SCENIC PINES ESTATES JSP18-76

Public hearing at the request of Singh Development for Preliminary Site Plan With One-Family clustering Option, Site Condominium, Special Land Use, Wetland Permit, Woodland Permit and Stormwater Management Plan Approval. The subject properties are approximately 9.44 acres and are located south of South Lake Drive and south side of Pembine Drive (Section 3). The applicant is proposing to utilize the One-family Cluster Option to develop a site condominium with 25 single family detached homes.

PLANNING REVIEW

Planning Review **SCENIC PINES ESTATES**

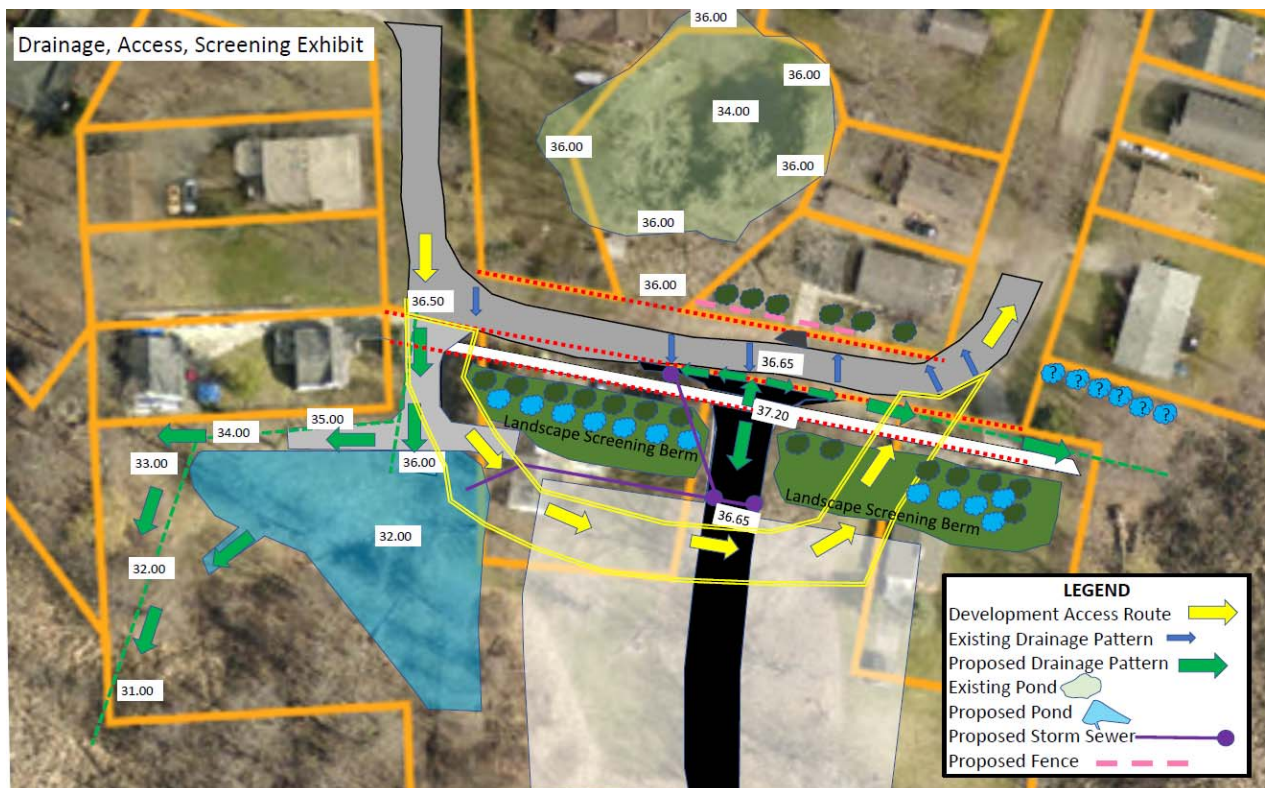
There is one house that sits on the opposite side of Pembine Street which is located at the proposed entrance driveway into the development (See picture to the left).

Figure 2. Wetland Plan, provided by Diffin-Umlor & Associates. The apparent project boundary is shown in red and existing, delineated wetlands are shown in green.

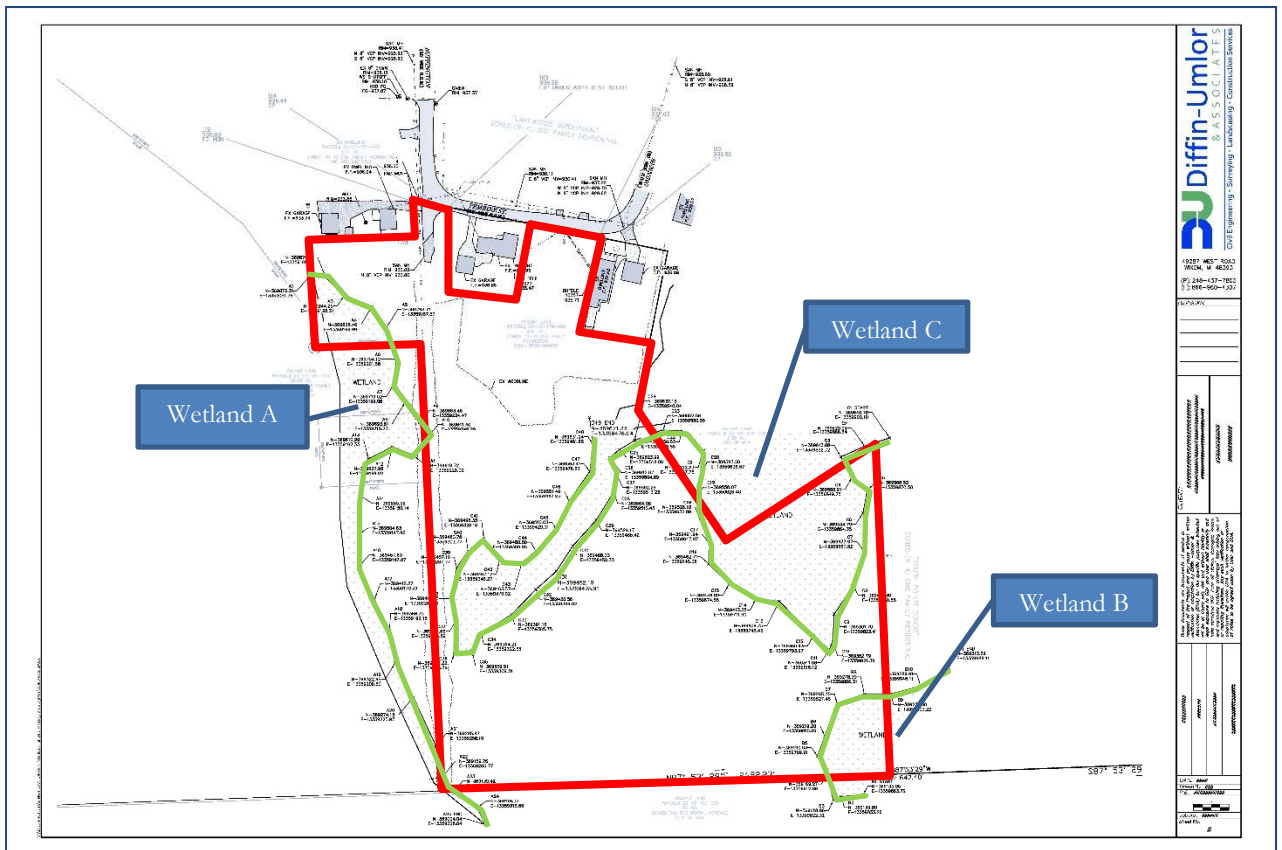
Figure 2, attached. It is however ECT's opinion that several flags along the south and east sides of Wetland C shall be re-flagged. The Wetland C boundary in the area of flag C9 and C16 should be re-flagged by the applicant's wetland consultant. These areas of wetland flags were hung on trees that were within areas of standing water at the time of our wetland boundary evaluation. Additional signs of hydrology were also present outside of the currently-flagged wetland boundary in these areas including water-stained leaves and water marks on tree trunks.
